**AMENDMENT A00002: RFI RESPONSES/CLARIFICATIONS for SOLICITATION**

**VA257-12-R-0057 – NEW WACO ENERGY CENTER PROJECT**

**Attachment Part 1 of 2**

## RFI Responses

**Office of Construction and Facilities Management**  
225-MS1.2  
225-MS1.2  
225-MS1.2

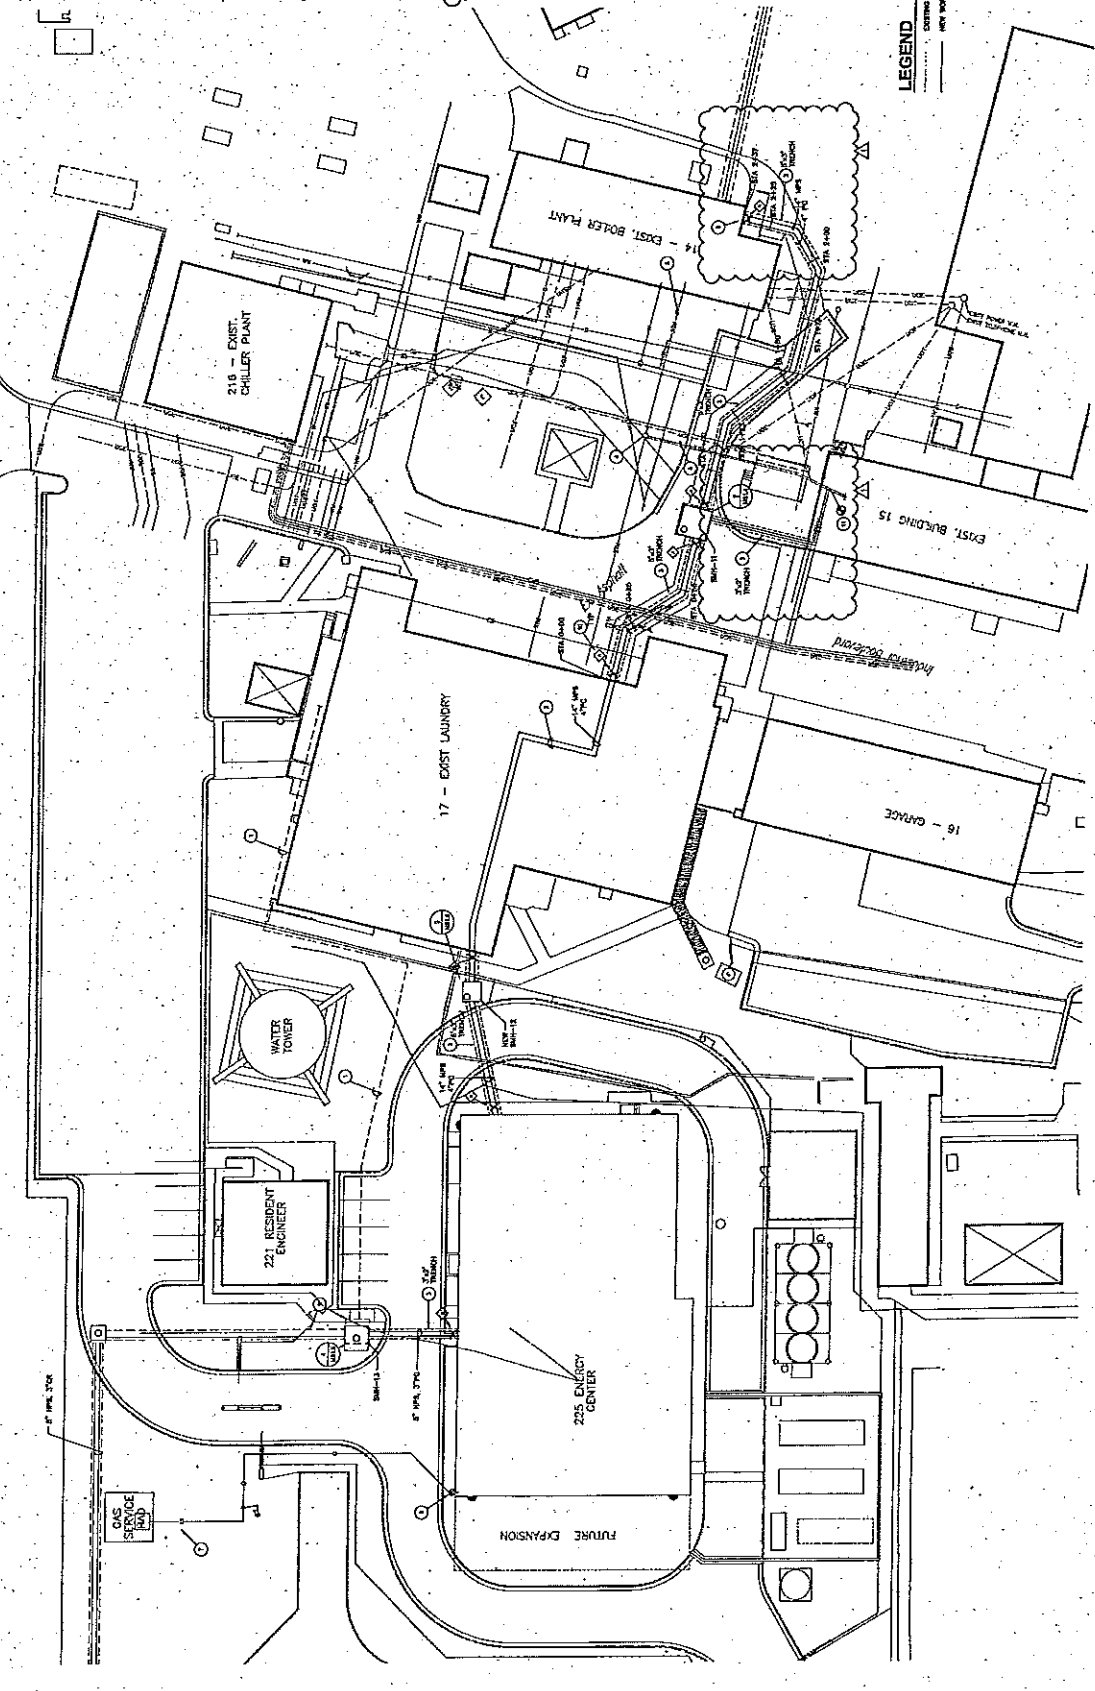
- Item #3 – Sheet 225-MS-1.2: Replace Sheet to show new concrete trench to Bldg. 15, revised concrete trench to Bldg. 14 and deletion of SMH-8.
- Item #4 – Sheet 225-MS-1.3: Replace to show deletion of SMH-8.

1 STEAM TRENCH - MANHOLE SMH-13 TO BUILDING 225  
HORIZONTAL SCALE 1"=10'  
VERTICAL SCALE 1"=3'  
SCALE: 1"=10'

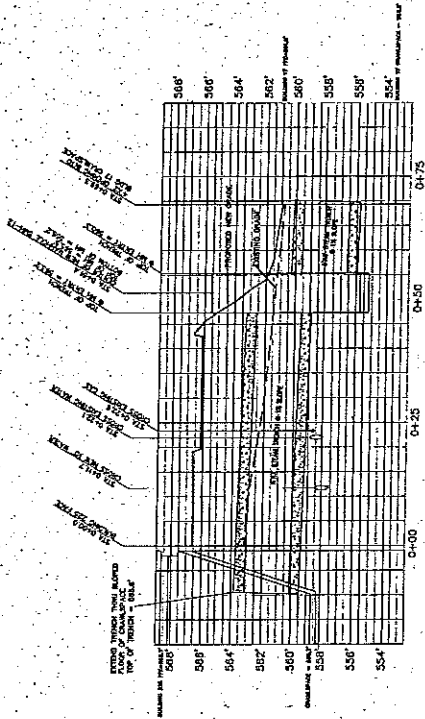
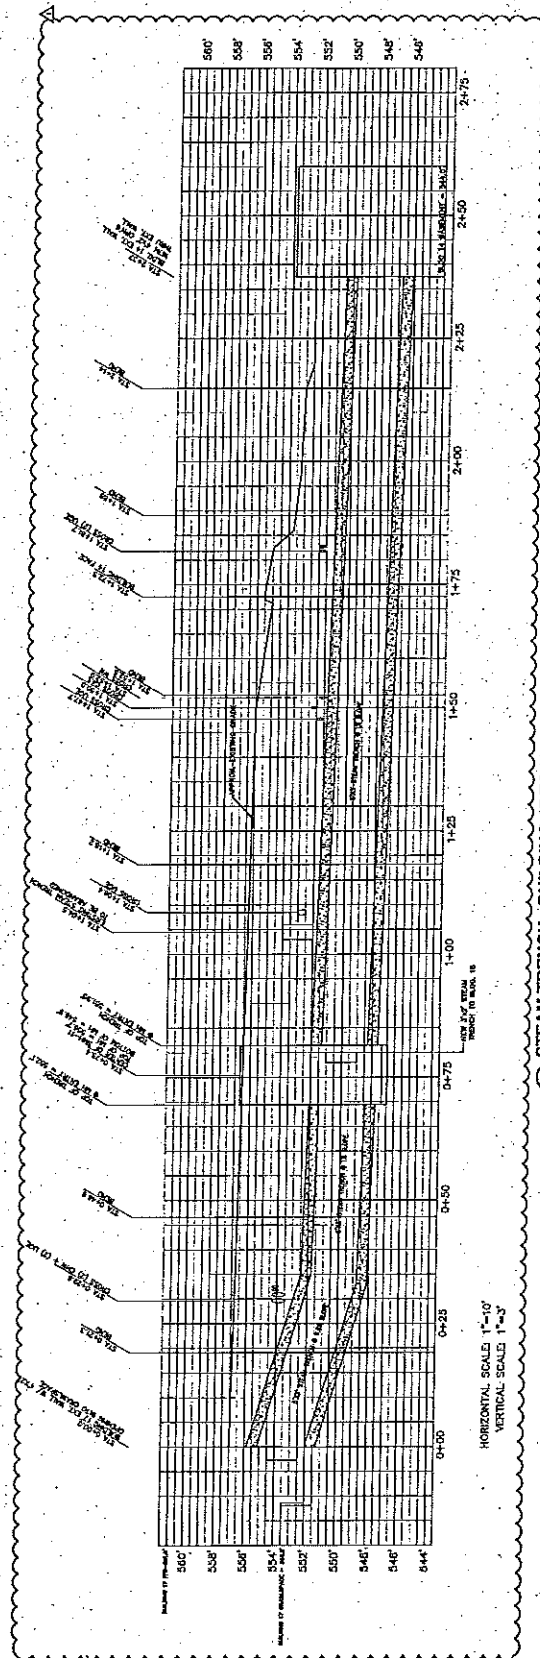
- Item #9 – Sheet 225-MS-1.9: Replace Sheet to show revised steam trench profiles
- Item #10 – Sheet 225-MS-2.1: Replace Sheet to delete of chilled water valves and revise Phasing Plan.
